I. **P22-156:** 135 N. Cache St., 120 & 145 N. Glenwood St. - Development Plan Amendment for Hotel Jackson

Meeting Date:	September 21, 2022	Meeting Title:	Planning Commission
Submitting Department:	Planning Department	Presenter:	Tyler Valentine
Agenda Item:	P22-156 Development Plan Amendment for Hotel Jackson at the properties addressed at 135 N. Cache Street, 120 & 145 N. Glenwood Street.	Public Comment:	Yes

**RE: 120 N Glenwood Street
Development Plan Amendment (revised 8.25)**

A1 NORTH ELEVATION - RENDERED (7.29.22)
SCALE: 3/16" = 1'-0"

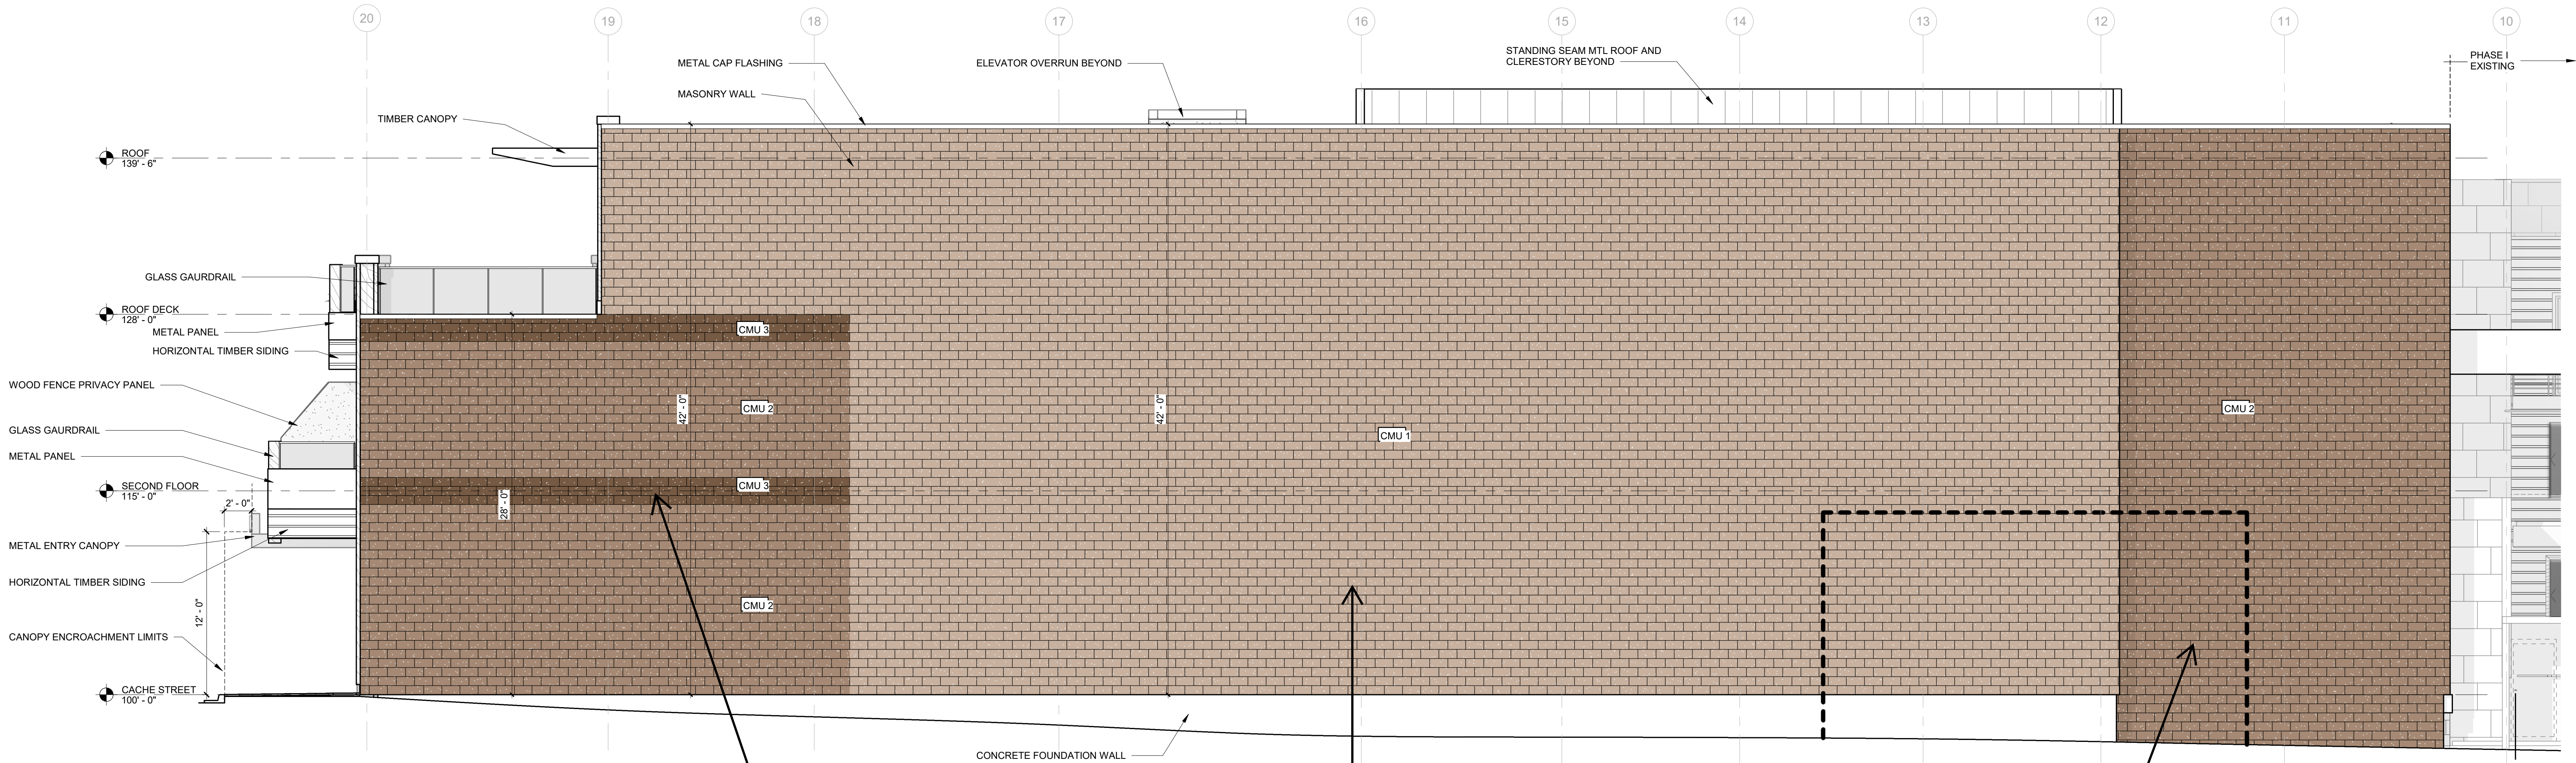
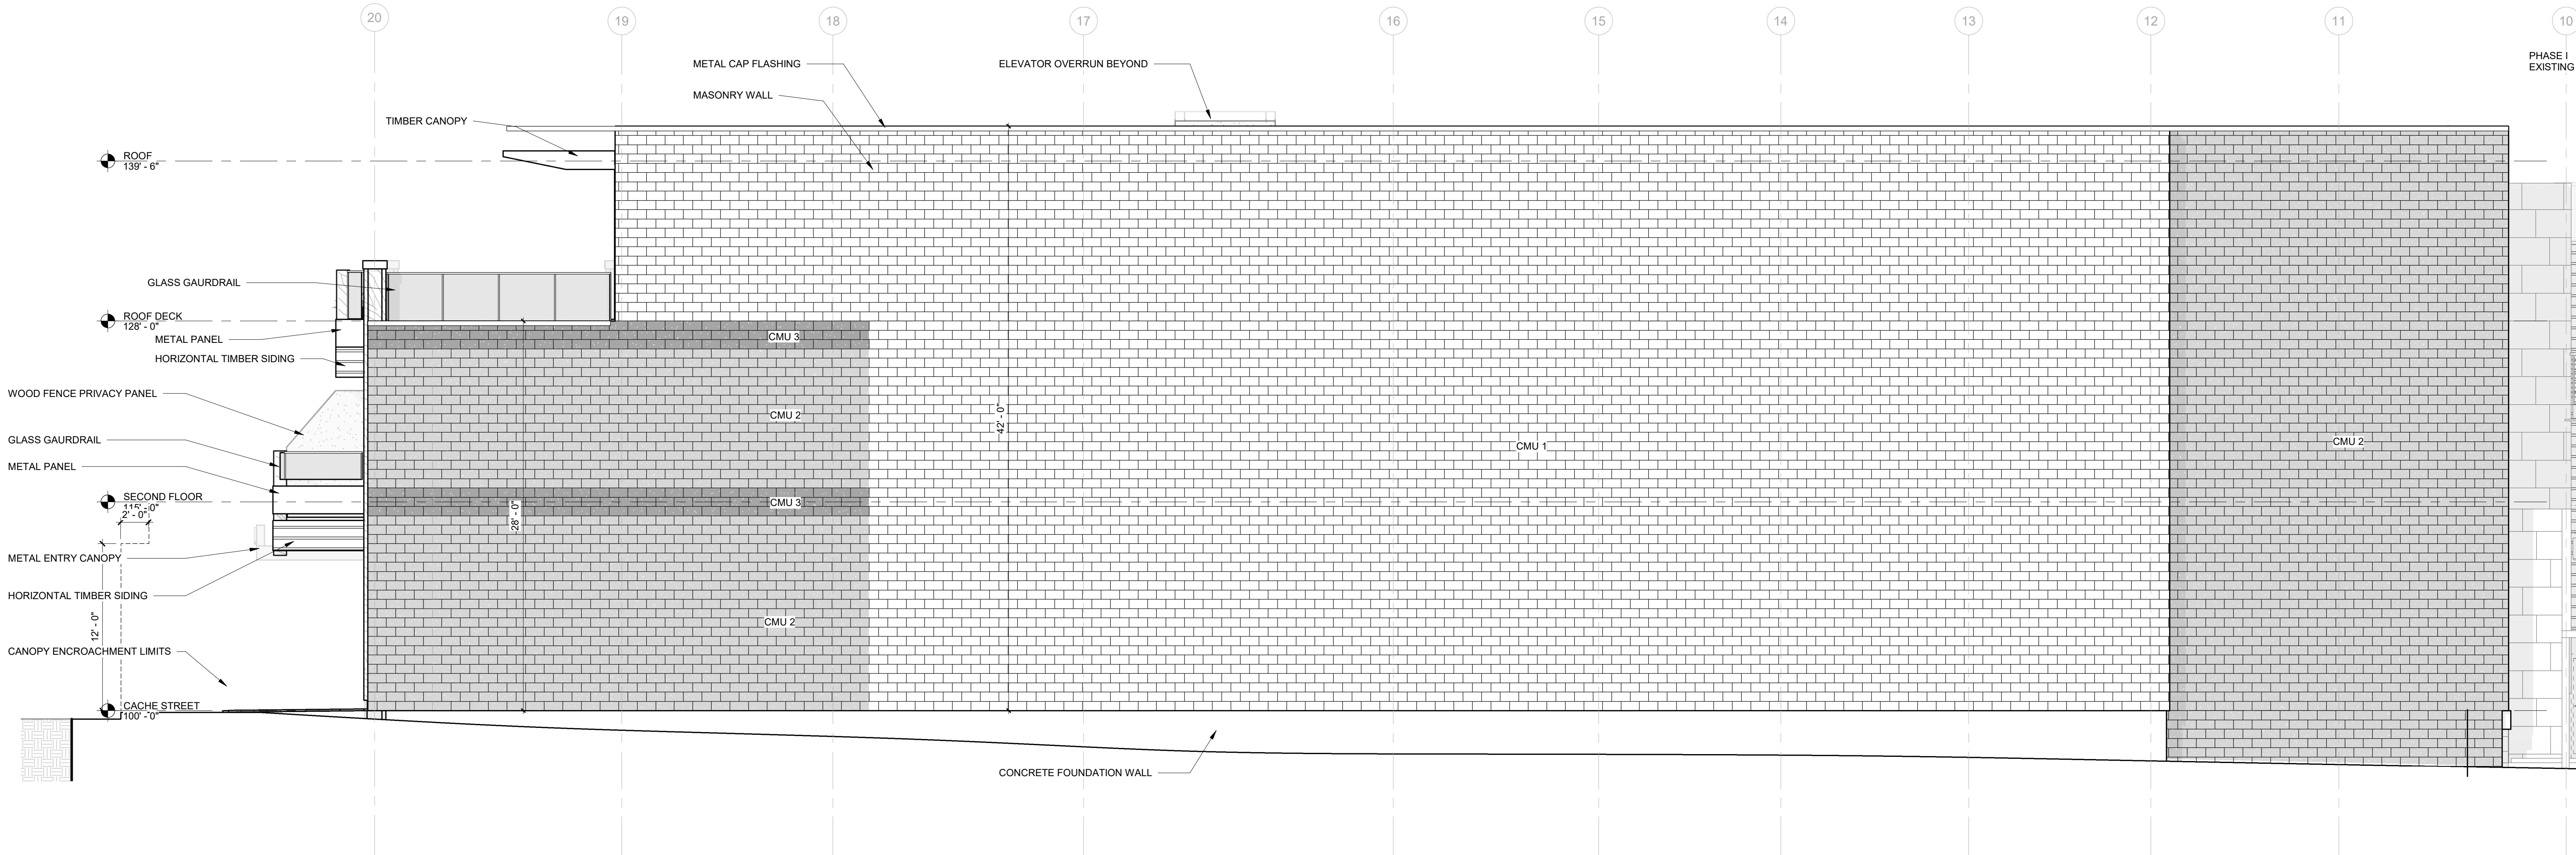
One notable change is along the northern wall which previously included wood and metal materials consistent with the rest of the building. Due to complications with the property owner to the north (St. John's Episcopal Church), the applicant will not be granted any temporary construction access on the church property which limits the types of materials that can be used on the north elevation. As a result, the applicant is proposing a CMU wall since CMU is a material that can be installed entirely from the applicant's property. The smooth-faced CMU is not simply one color but consists of 3 shades of gray in horizontal patterns.

- North facing wall along adjacent church property to be a patterned CMU wall. This change is needed in response to the adjacent property owner denying temporary construction access to facilitate construction.
- Second floor windows along Cache Street have moved. The balconies above Cache Street remain.
